From: Bruce Zoeller <bzoeller@thechristianadvantage.com>
Sent: Wednesday, December 13, 2023 7:59 PM
To: Davis, Brian
Subject: Floyds Fork Zoning Overlay District - comments

From: David A Dries <davidadries@gmail.com>
Sent: Saturday, December 16, 2023 4:14 PM
To: Davis, Brian
Cc: Kim Brice
Subject: Comments on the Floyds Fork Zoning Overlay District

From: kacey <kaceydf@fastmail.com>
Sent: Tuesday, December 19, 2023 2:21 PM
To: Davis, Brian
Cc: O'Brien, Jeff; Piagentini, Anthony; Benson, Stuart; Kramer, Kevin; Engel, Robin; Winkler, Markus; Ruhe, Betsy; Owen, Andrew
Subject: Re: Floyds Fork DRO/ZOD revisions comments

Floyds Fork ZOD revisions

Aiken Rd

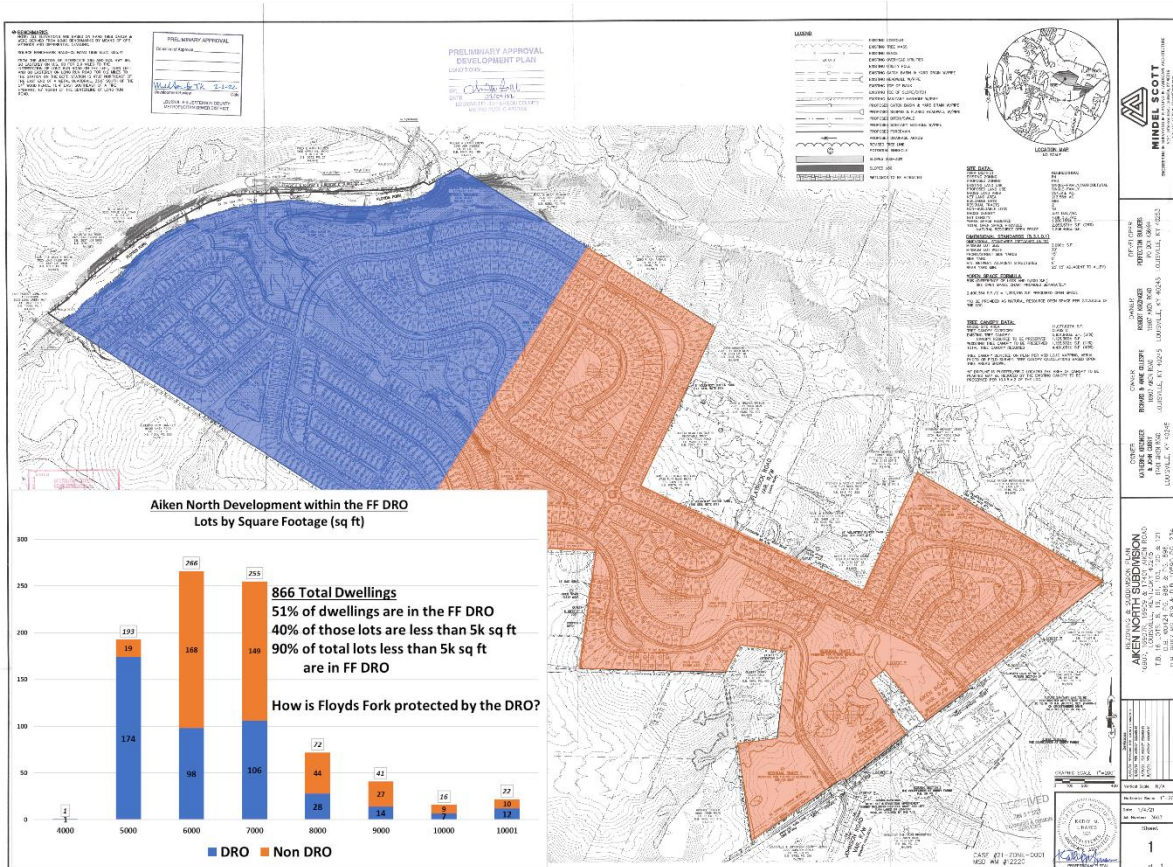
Please note that there is one lot in the DRO portion that is less than 4,000 sq ft!

- i. This property does not have any floodplains
 - c. 16907 Aiken Rd (21-ZONE-0001)
 - i. This property was more densely developed in the DRO than the non-DRO portion
